IE INSPECTION RPT 50-483/78-01  
UNITED STATES  
NUCLEAR REGULATORY COMMISSION  
WASHINGTON, D. C. 20555

SUBJECT: RESOLUTION OF ITEMS IDENTIFIED BY REGION III DURING  
SPECIAL INVESTIGATIONS AT CALLAWAY, UNIT 1 RELATED  
TO CONCRETE CONTAINMENT

## MINUTES OF MEETING ON JANUARY 23, 1978

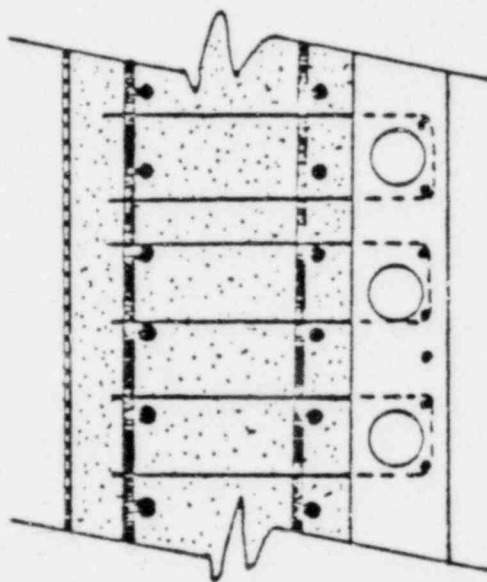
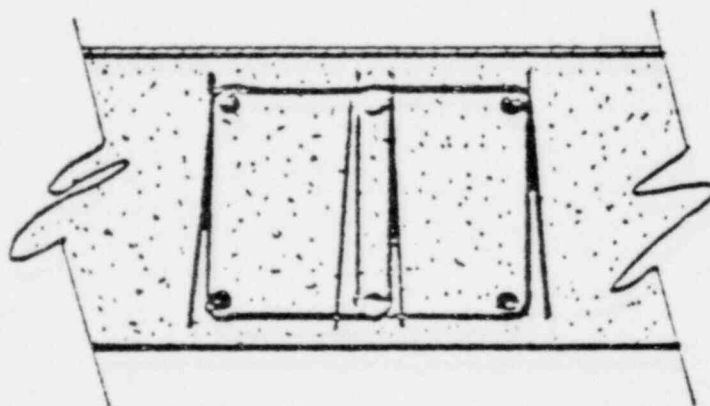
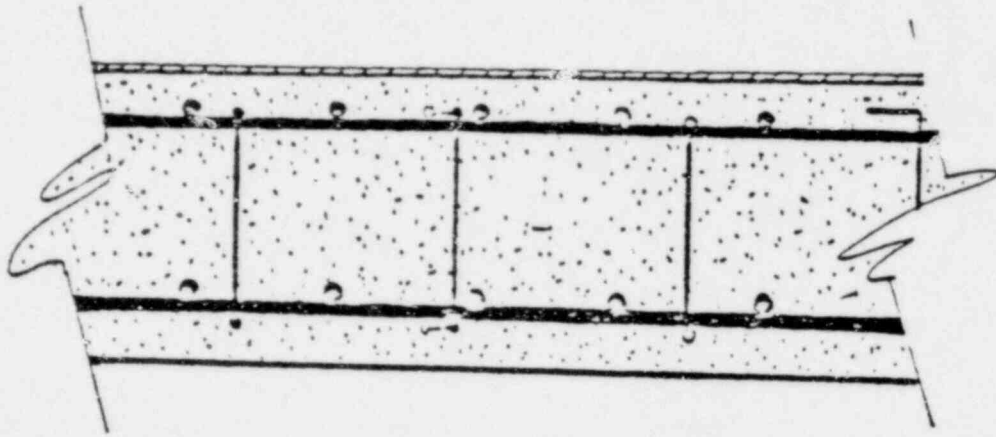
Bechtel explained that Section CC-3532.1 of Appendix C of BC-TOP-5A, Revision 3 allowed three configurations for radial shear reinforcement known as the transverse, simple-U and multiple-U (See Figure 1). Bechtel is using the transverse type in the normal wall sections with the other types possible for use in areas of tendon anchorages such as buttresses, penetrations, and the construction opening. Bechtel indicated that there is no requirement that the bends of bar engage and enclose the inner and outer face vertical reinforcing since the requirement is only a standard hook and  $0.5 l_d$  as an effective embedment. In order to assure proper embedment in the outer face, Union Electric will place and verify that the radial shear reinforcement has the outer leg outside the plane of the vertical reinforcing steel. Bechtel also explained that the legs of the bar could be oriented at any angle.

Upon discussion, NRR and IE agreed that these criteria were adequate for the anchorage of radial shear bars. This discussion then lead to the question of where in elevation the radial shear reinforcement was not needed and where the radial bars were then actually the radial tension reinforcement. Radial tension reinforcement is added voluntarily by Bechtel to preclude gross delamination within the shell thickness.

1. Criteria for Radial Shear Reinforcement (including radial tension reinforcement) - The staff (NRR and IE) agreed that the anchorage of the radial shear reinforcement should be such that the outer leg bend of the bars be outside the vertical plane of the outside face vertical steel and that the inner leg end of the bar meet the requirements of a standard hook plus an effective embedment of  $0.5l_d$ . It was also agreed that the radial shear bars do not need to be located so as to engage any other specific reinforcing and that the outstanding legs from the standard hooks can be rotated into any 360° position. The licensee indicated that these criteria would be followed.

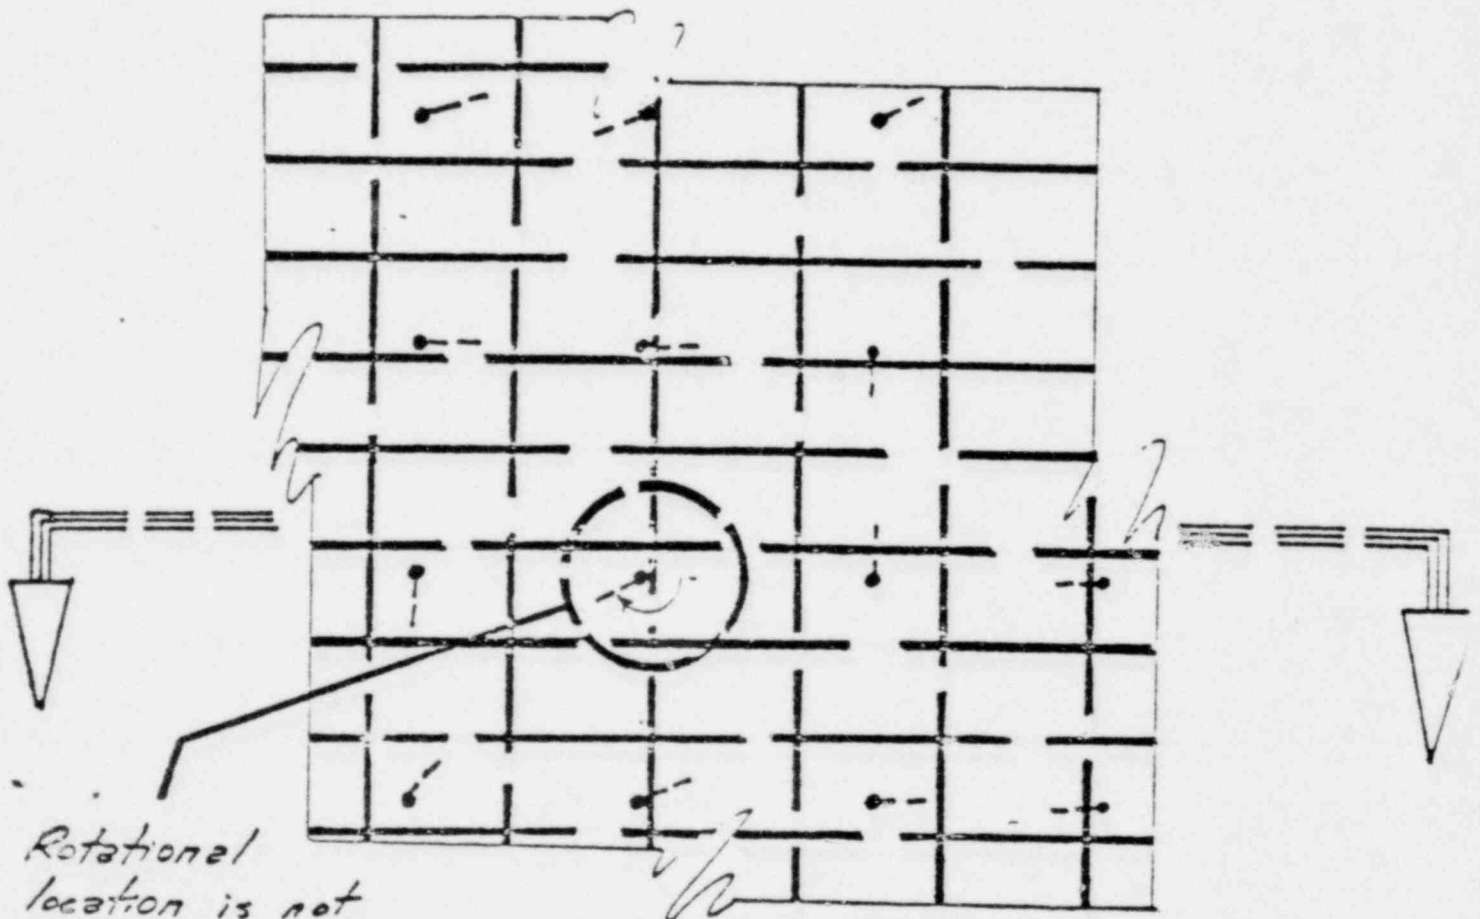
A discussion was provided on the various changes Bechtel had issued to construction as DCN's on the details of radial shear reinforcement placing. The technical basis for those changes were also discussed. It was suggested by the staff that Bechtel Drawing C-OR2901 (Q) be revised in the detail entitled "Typical Wall Elevation Shear Test" (actually a sectional view) so that a typical case instead of a special case is shown. A clarified drawing including an elevation would make the intent clearer (See Figure 2).
